**NRC DOCKET#:** NRC-2015-0070

**TITLE:** Regulatory Improvements for Decommissioning Power Reactors

**Mark Leyse's Comments on the NRC's "Regulatory Improvements for  
Decommissioning Power Reactors;" Proposed Rules; NRC-2015-0070**

Figure 1. Local Cladding Temperature vs. Time in the PHEBUS B9R-2 Test<sup>119</sup>

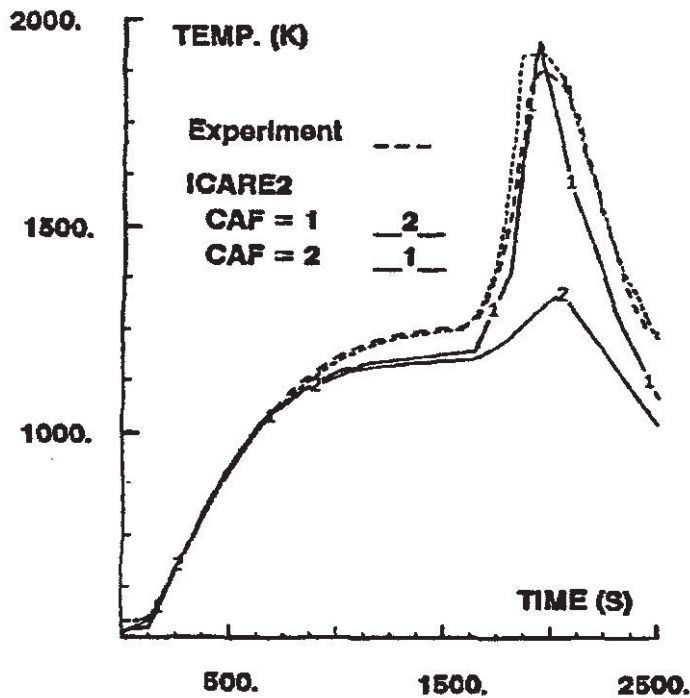
Commission report states that the B9R-2 test had an unexpected fuel-cladding temperature escalation in the mid-bundle region (see Figure 1); the highest temperature escalation rates were from 20°C/sec (36°F/sec) to 30°C/sec (54°F/sec).<sup>117</sup>

The B9R-2 test (second part of B9R) illustrates the oxidation in different cladding conditions representative of a pre-oxidized and fractured state. This state results from a first oxidation phase (first part name B9R-1, of the B9R test) terminated by a rapid cooling-down phase. During B9R-2, an unexpected strong escalation of the oxidation of the remaining Zr occurred when the bundle flow injection was switched from helium to steam while the maximum clad temperature was equal to 1300 K [1027°C (1880°F)]. *The current oxidation model was not able to predict the strong heat-up rate observed even taking into account the measured large clad deformation and the double-sided oxidation (final state of the cladding from macro-photographs).*

... *No mechanistic model is currently available to account for enhanced oxidation of pre-oxidized and cracked cladding*<sup>118</sup> [emphasis added].
